**7. COA-044104-2018**

2218 E Grace Street

**Replace front porch columns, add rear deck and new door, and alter existing fence.**

Figure 1. 1905 Sanborn Map  
Key: pink indicates masonry, yellow indicates frame.

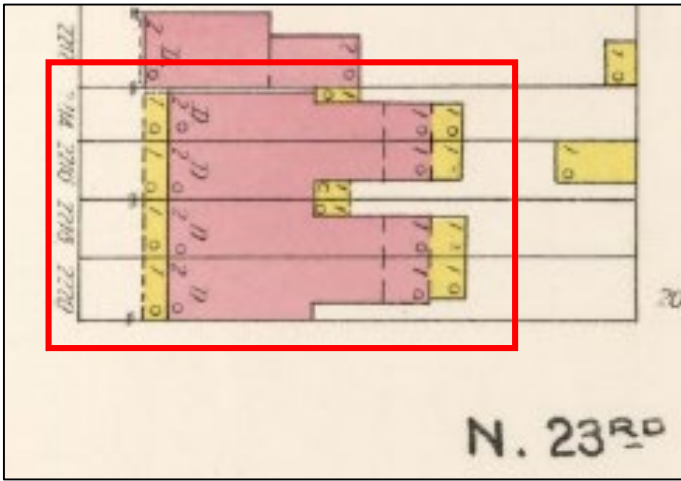
Historic Sanborn maps indicate that there was originally an opening on the rear elevation that provided access to a one-story, frame section. The frame section is no longer extant. Current photographs indicate there are replacement bricks on the rear elevation of the parapet wall. Based on the Sanborn maps and current condition of the masonry, staff believes there was originally an opening on this elevation. Staff further finds this elevation is on the rear of the building and will be mostly screened by an existing fence and vegetation. Based on the historic Sanborn maps, current condition of the brick, and very limited visibility of this elevation, staff recommends approval of the proposed door opening.
